Flight Procedures Cover Page	Task Action: FLIGHT CHECK	Task Type: IAP	Estimated Chart Date: 12/02/2021	APWS Task ID: 53C36C00BAF4435F8D4F8304CE4D536C	APWS Project ID: 93DEC047914E49CA9AA789771C1AF327
Procedure: RNAV (GPS) RWY 7 AMDT 1		Enroute: NO	Specialist: Young, Silvia		Agreement Number:
Airport ID: KOKB			Airport City: OCEANSIDE		State: CA
Facility ID:	Facility Type:	Flight Inspection Remark Type: New FC Slot			
Procedure Comments: ACTIVE DATA USED FOR KOKB AIRPORT. CONTACT LONNIE EVERHART 202.450.0180. J ZEDER 07/15/2021

FIPC BASIC FORM						
PROCEDURE: RNAV (GPS) RWY 7 AMDT 1			AIRPORT NAME: BOB MAXWELL MEML AIRFIELD		AIRPORT ID: KOKB	SPECIAL CONTROL NO: SG-07-228-21
FAC ID: KOKB07.01		CITY: OCEANSIDE			ST: CA	ORIG CHART DATE: 12/02/2021
DFL TYPE: PROC/G	THIRD PARTY: ☐ YES	EST. TIME ON SITE: 0.5	REIMB. NUMBER:	PTS TASK ID:		
PREFLIGHT NOTES						
REVIEWER:					DATE:	
COMMENTS:					CHECK ONE: ☐ FLT CK REQ ☐ NFCR ☐ REJECT	
						YES
					CPV COMPLETE? ☒ X	
PROCEDURE RESULTS						
INSPECTION DATE: 08/24/2021	CREW #: VN234	N #: N68	INSTRUMENT PROCEDURE STATUS: ☒ SAT ☐ SAT W/CHANGES ☐ UNSAT		ARINC CODING: ☐ SAT ☐ SAT/GOLD ☐ UNSAT	
FLIGHT INSPECTOR SIGNATURE: daniel c favorite @

AUTOMATED AL-5666 RNAV (GPS) RWY 7
 AUTOMATED AL-5666 RNAV (GPS) RWY 7

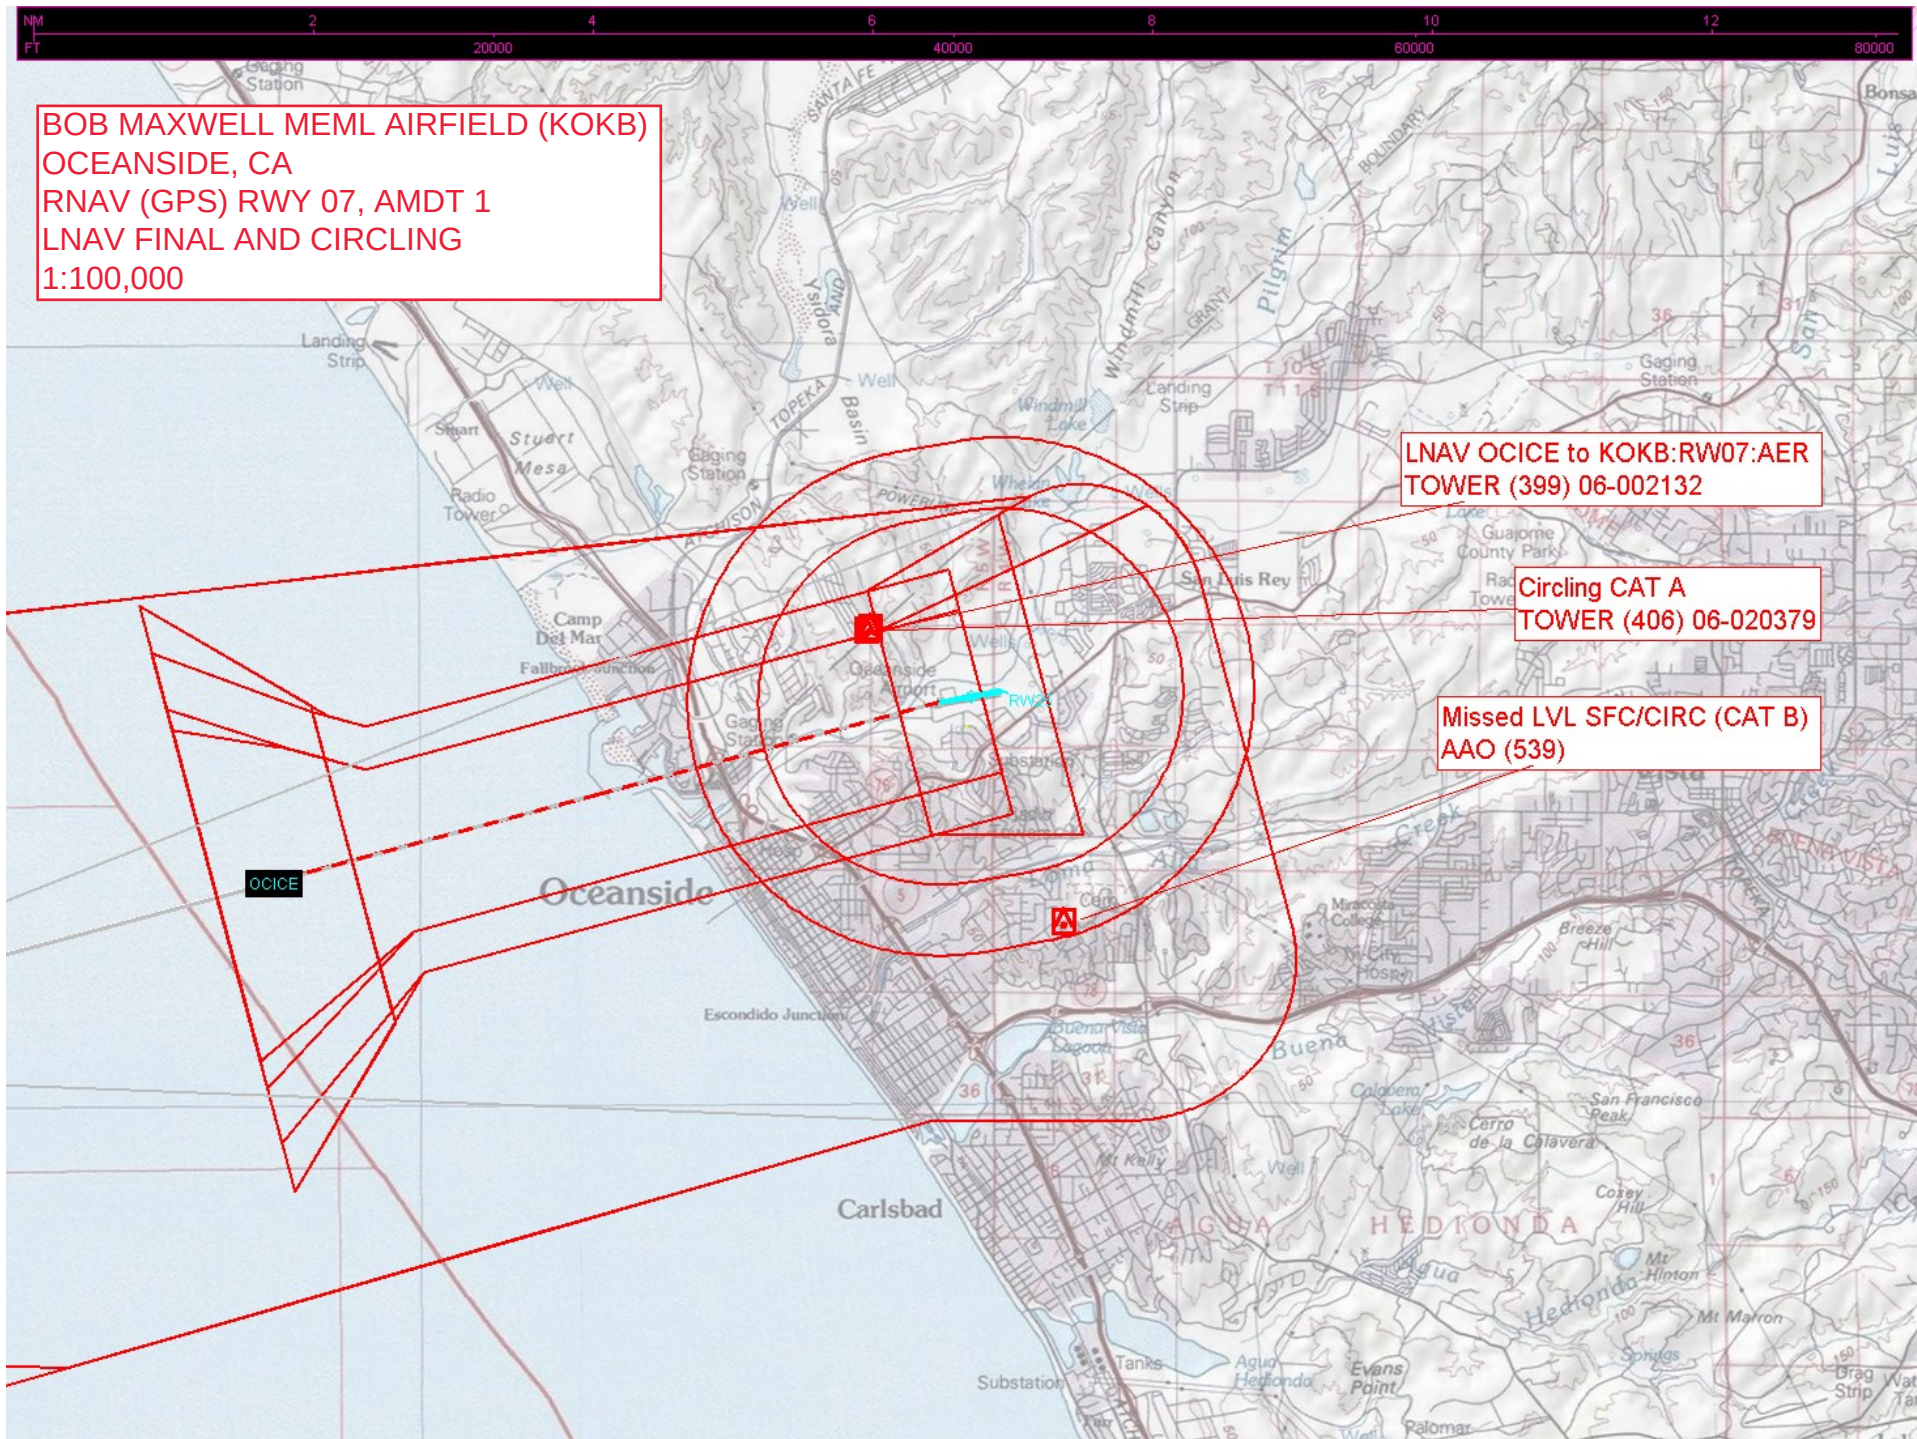
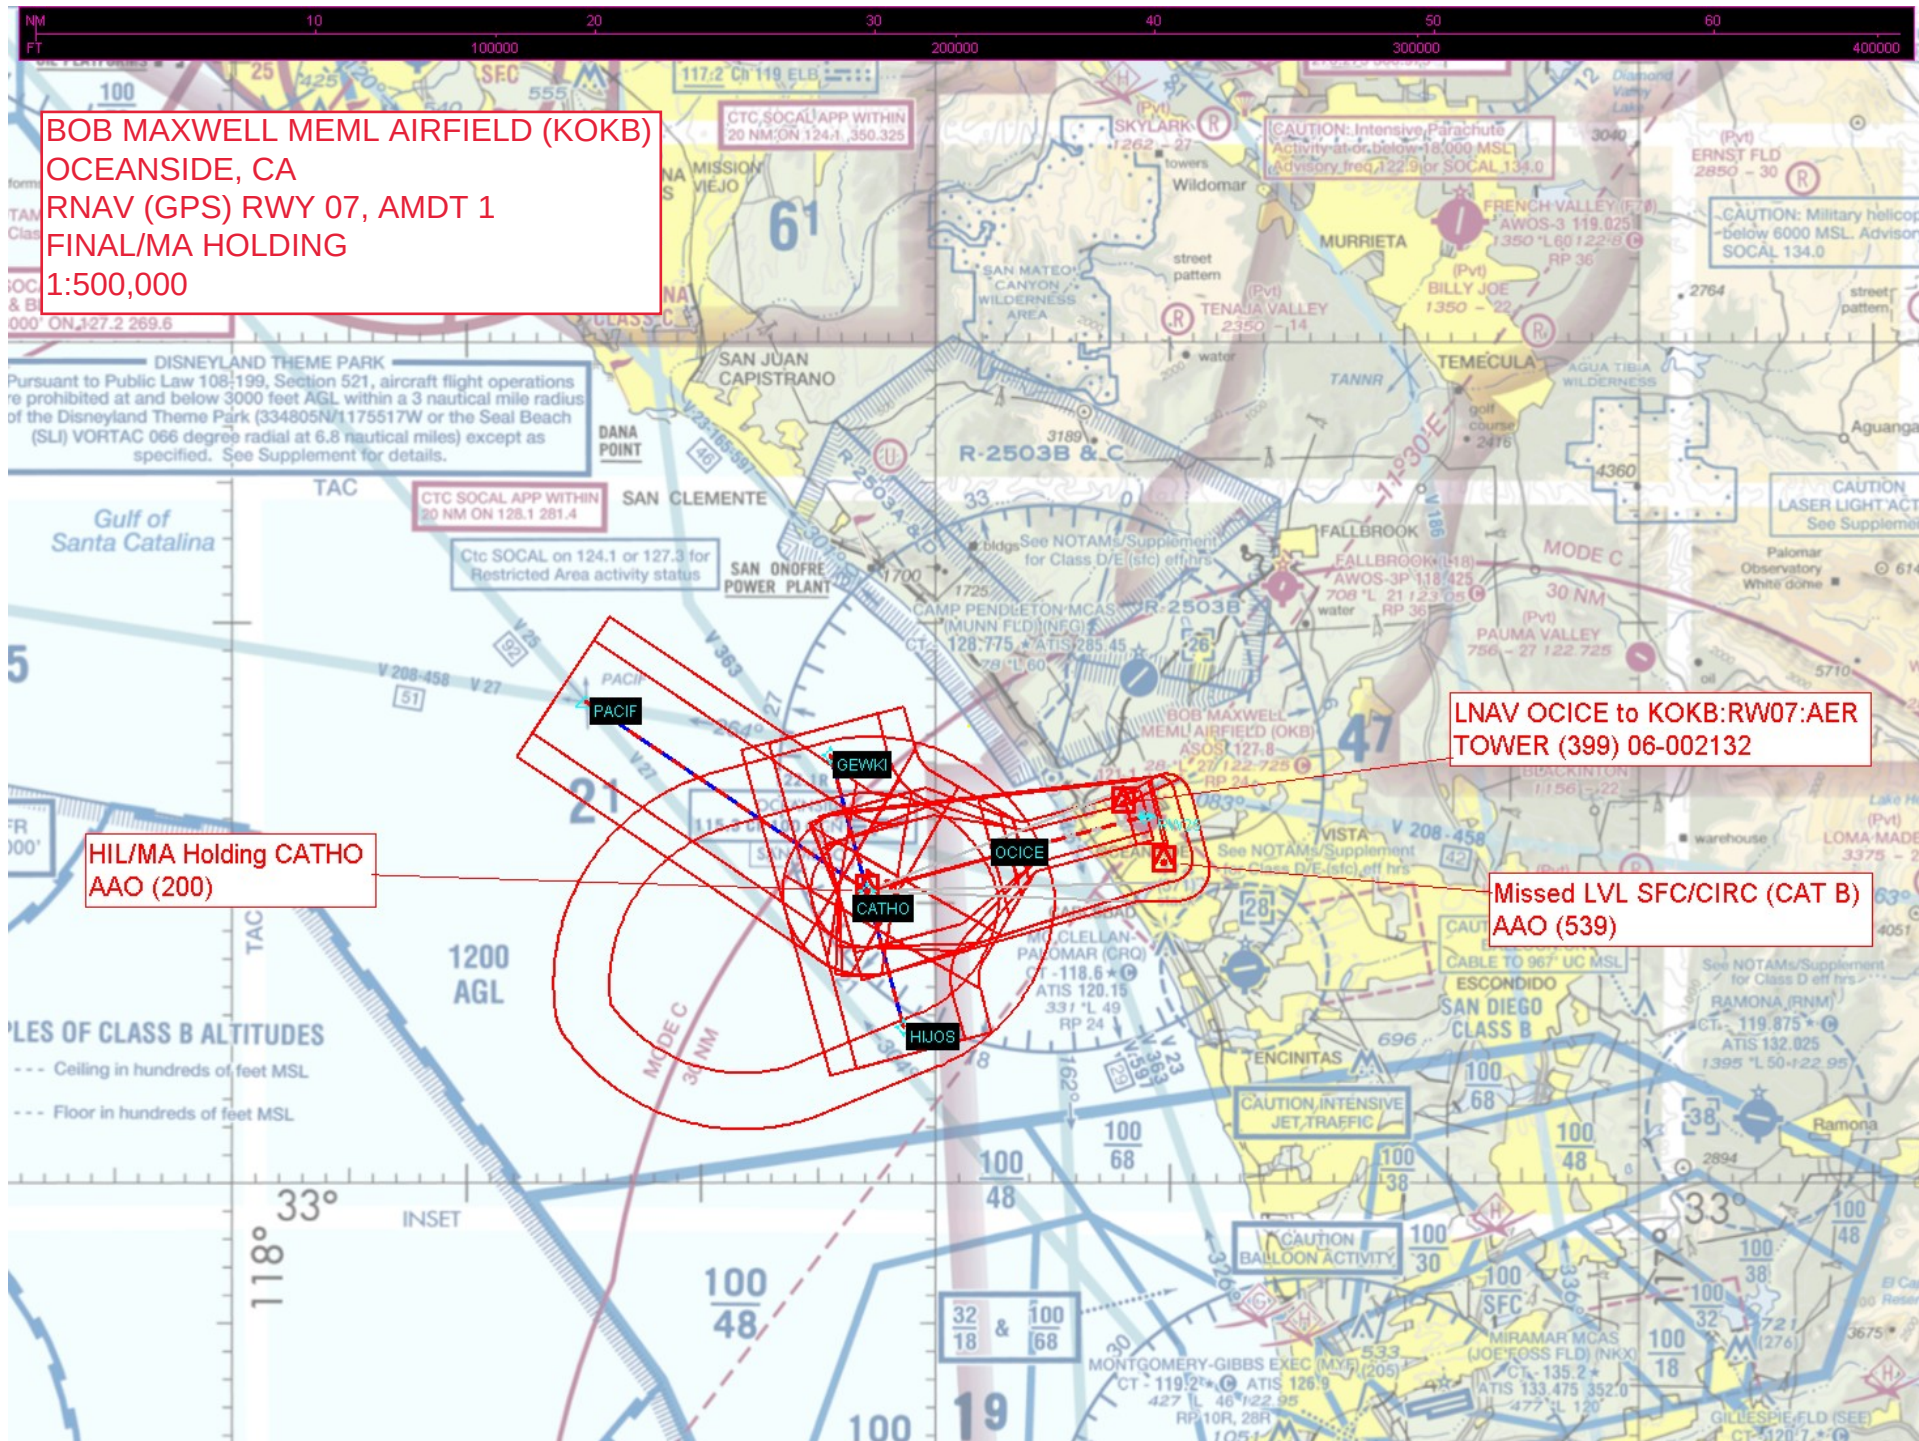
The procedure name change from RWY 6 to RWY 7 was the only change; no other modifications were made to the RNAV (GPS) RWY 7 procedure.

RNAV (GPS) RWY 25:

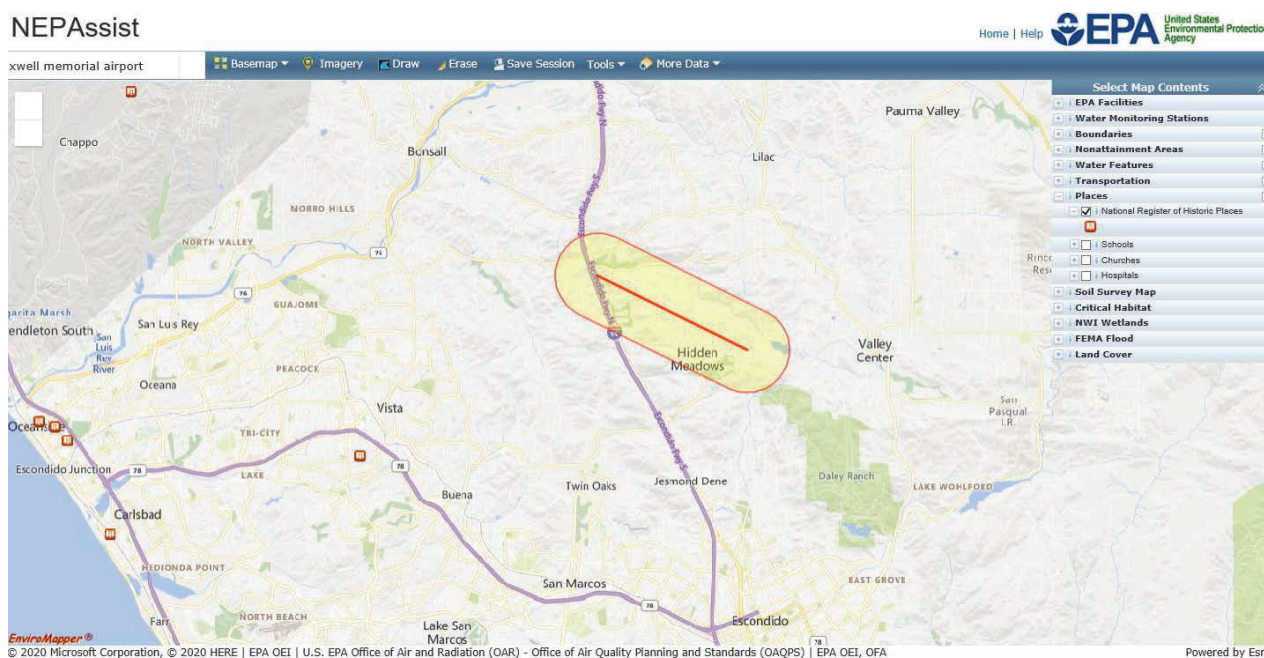
The procedure name change from RWY 24 to RWY 25. The following are amendments to the procedure.

- Initial segments
 - FITMU initial approach fix (IAF) to GIWHE waypoint (WP)—no change
 - HIXAL IAF to GIWHE WP—minimum altitude increased from 2,900 to 3,000 (ft) mean sea level (MSL), no location change.
 - BOND0 IAF to AJIYO step-down fix (SDF) to GIWHE WP—minimum altitude from BOND0 IAF to AJIYO SDF unchanged, minimum altitude from AJIYO SDF to GIWHE WP decreased from 3,100 to 3,000 ft MSL, no fix locations changed.
- Intermediate segment—GIWHE WP minimum altitude increased from 2,900 to 3,000 ft MSL. No change in location.
- Final segment—OCNIH precision final approach fix (PFAF) moved 2 nautical miles east to N33° 14' 20.1943" W117° 12' 36.2841" and minimum altitude increased from 1,800 to 2,500 ft MSL.

The only segment of the entire project being lowered is the segment from AJIYO to GIWHE and that is by 100 ft (from 3,100 to 3,000 ft MSL).
